SITE PLAN REVIEW AND APPEARANCE BOARD STAFF REPORT

Delray Townhomes

Meeting	File No.	Application Type
November 29, 2023	2021-025	Level 3 Site Plan (previously a Class V – classifications have changed in accordance with the adoption of Ordinance 31-23)
Property Owner		Agent
Ocean Ridge Rentals LLC		Kimley Horn and Associates

Consideration of a Level 3 Site Plan Application, including a Landscape Plan and Architectural Elevations, for a 25-unit multi-family development.

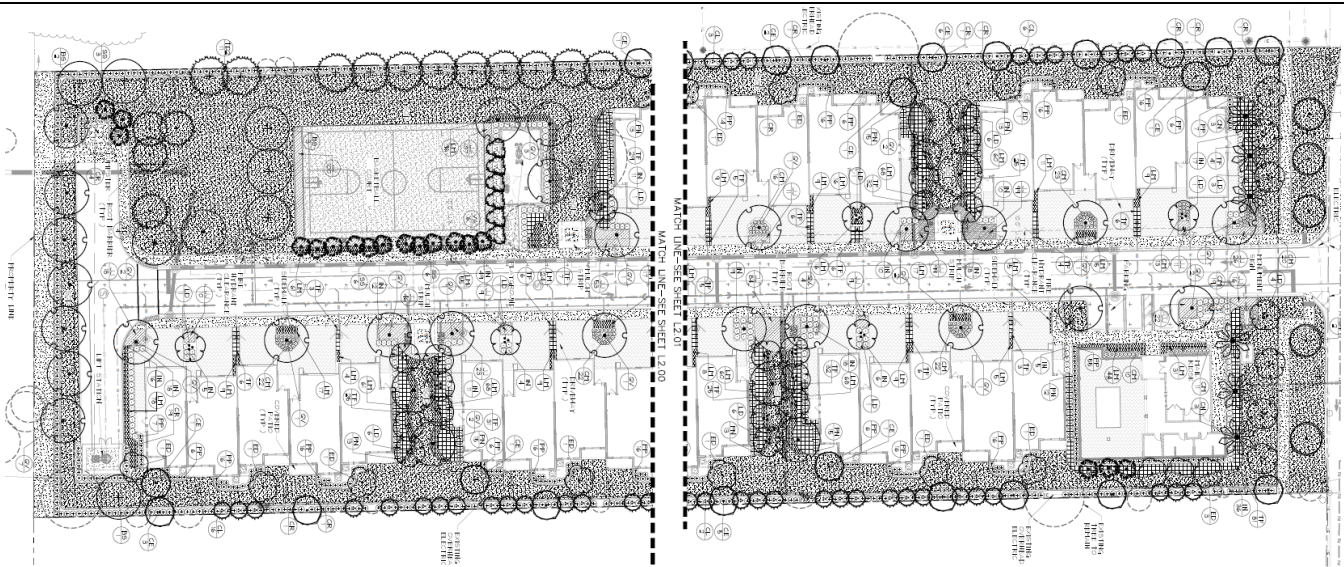
The Landscape Plan has been reviewed for technical compliance by the Landscape Plan Reviewer and the scope of work has been deemed to comply with all applicable regulations. A thorough mix of shade trees, shrubs, and ground landscaping is interspersed throughout the site to help soften the mass of the buildings as well as accentuate and supplement the outdoor amenity space. A landscape buffer is proposed around the extent of the site to provide visual screening from adjacent properties. Requisite street trees are planted along the 133rd Road S corridor. The applicant has sufficiently met mitigation requirements for the removal of existing trees by providing new trees and palms on site (see mitigation table on L1.02 for more information). The applicant will be required to enter into a Landscape Maintenance Agreement for the street trees prior to issuance of a building permit.
